PG&E Letter DCL-03-109

Supplemental Information to Support License Amendment Request 03-10, "Revised
Steam Generator Voltage-based Repair Criteria Probability of Detection Method for
Diablo Canyon Unit 2 Cycle 12"

**Supplemental Information on Characterization of Steam Generator Indications
Regarding License Amendment Request 03-10, "Revised Steam Generator
Voltage-based Repair Criteria Probability of Detection Method for
Diablo Canyon Unit 2 Cycle 12"**

Response to NRC Questions Received on June 3, 2003

Figure 1

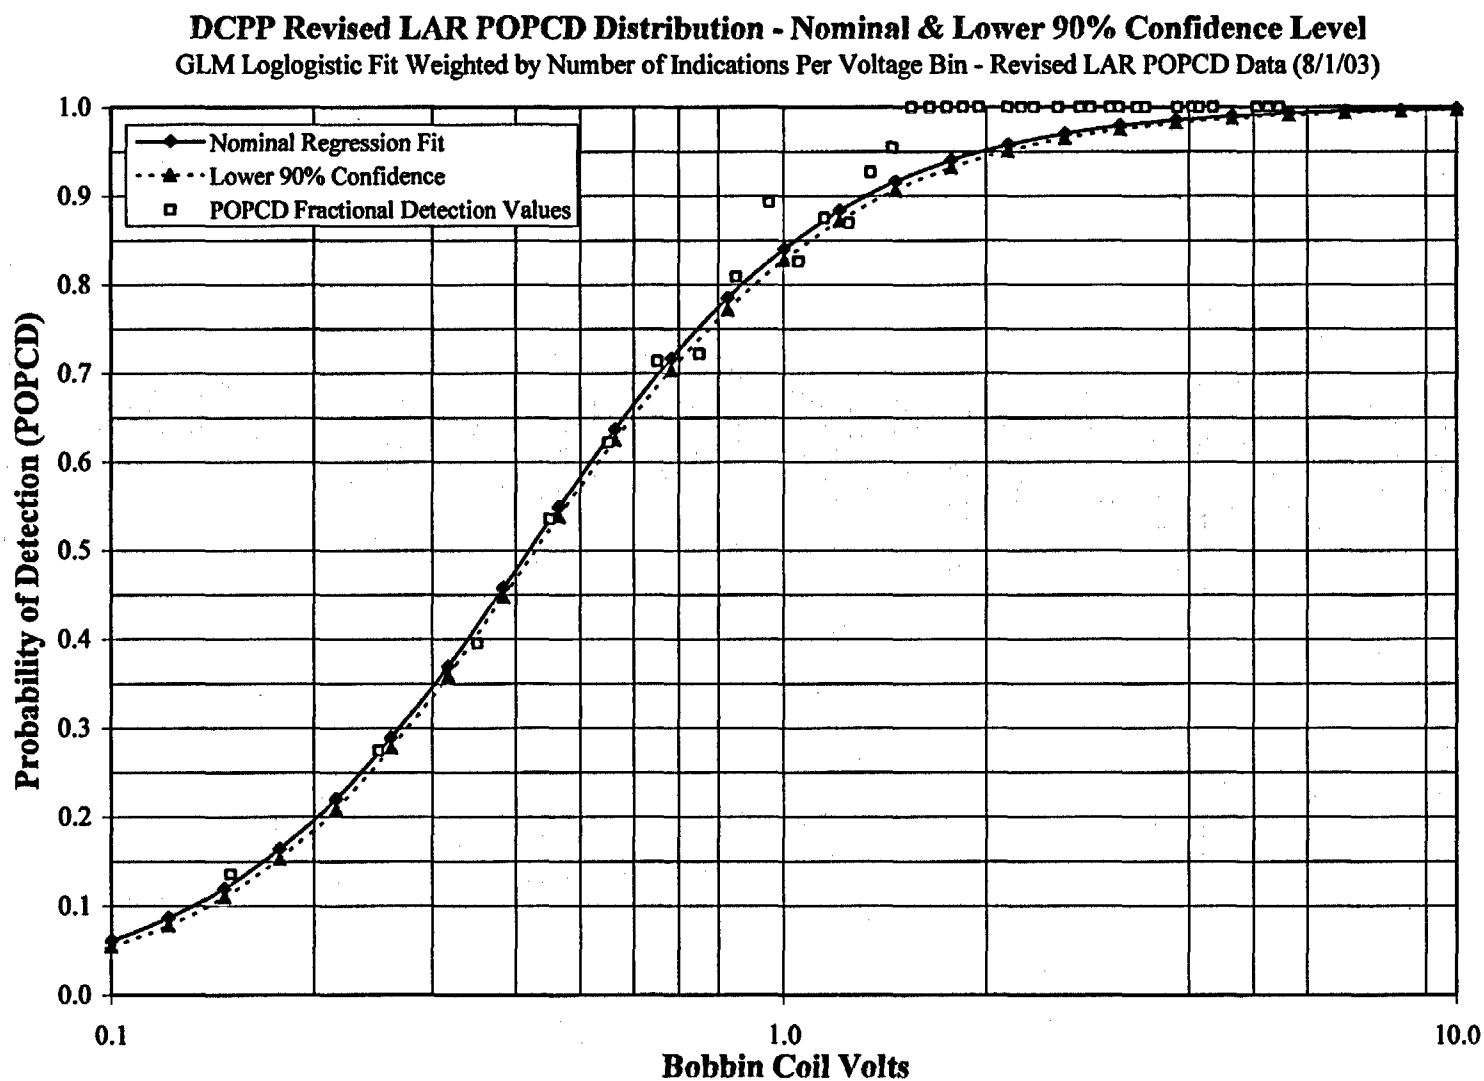
Figure 1 shows the loglogistic fit to the Table 1 Revised LAR POPCD data. The lower 90-percent confidence bound on the POPCD distribution and the fractional probability of detection (POD) data values are also shown for information. The fractional POD values are not used in the general linear model analyses since the POPCD analysis is weighted by the number of detected and undetected indications in each voltage bin. This figure replaces Figure 2 in DCL-03-078.

Therefore, PG&E recommends that Unit 2 Cycle 12 Monte Carlo analysis be based on the Revised LAR POPCD data in Table 1 and Figure 1. This recommendation is consistent with the requirements of GL 95-05, which requires that RPC NDD indications be included in the operational assessment as detected indications. Inclusion of the RPC NDD indications in the POPCD data as undetected bobbin indications would effectively further increase the number of RPC NDD indications in the operational assessment due to the decrease in POD for these indications.

Figure 2

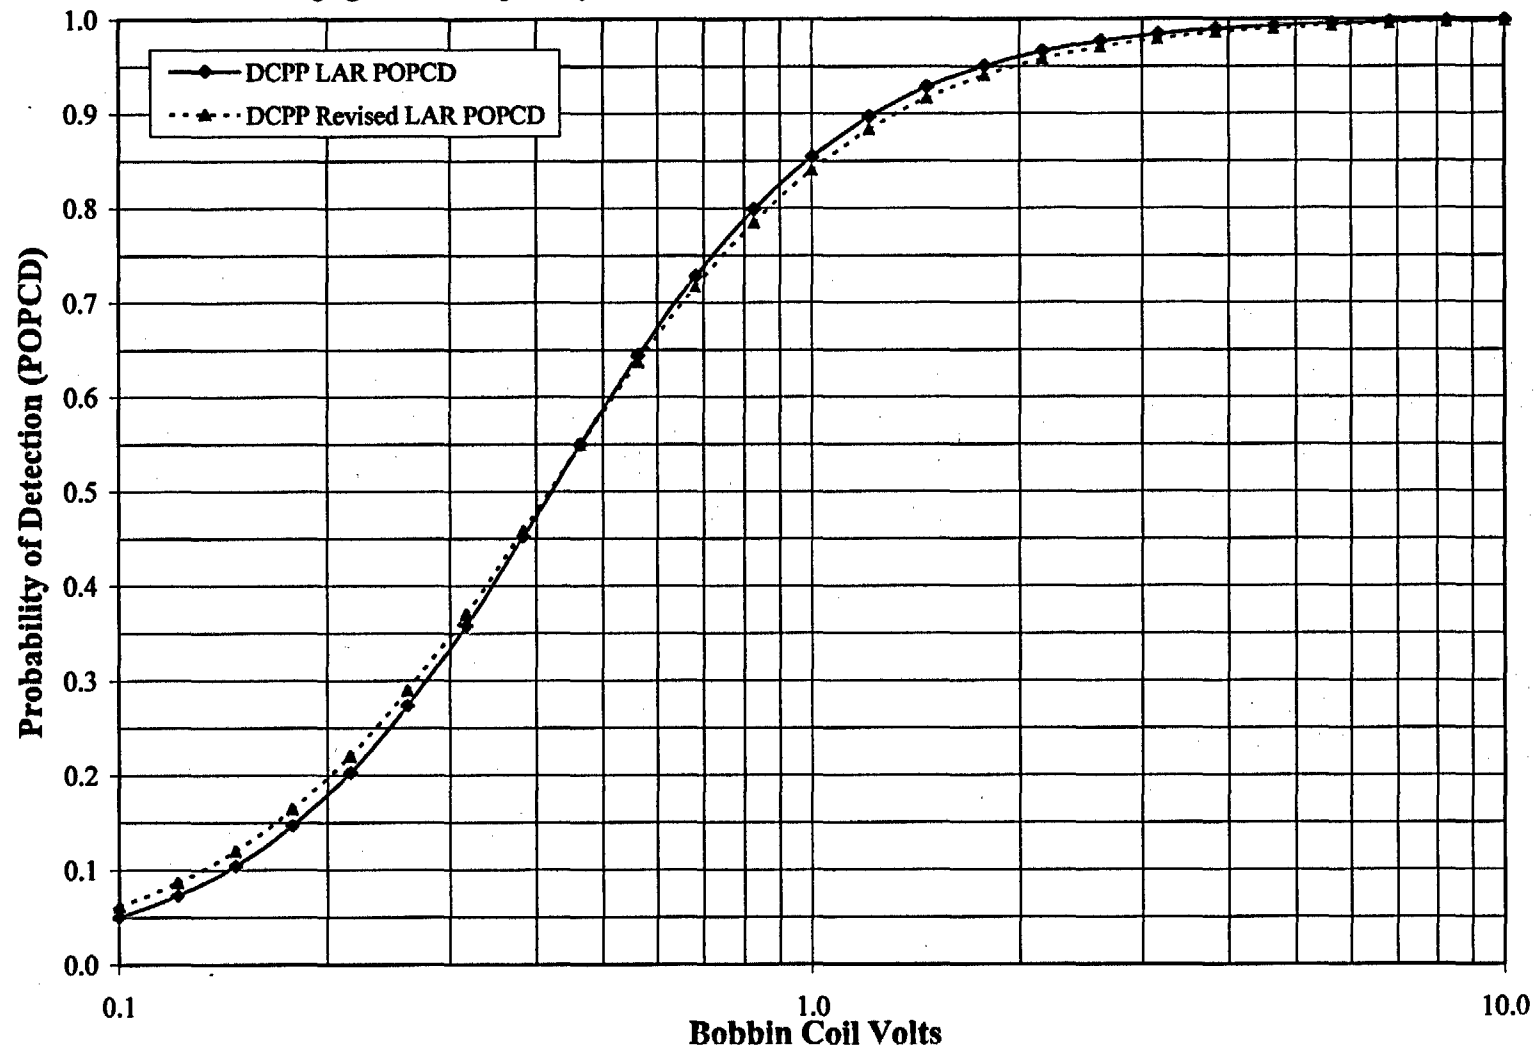
Figure 2 compares the loglogistic Revised LAR POPCD curve with the loglogistic LAR POPCD curve (from Figure 2 in DCL-03-078). Compared to the LAR POPCD data, the Revised LAR POPCD data decreases the POD above about 0.5 volt and increases the POD below about 0.5 volt.
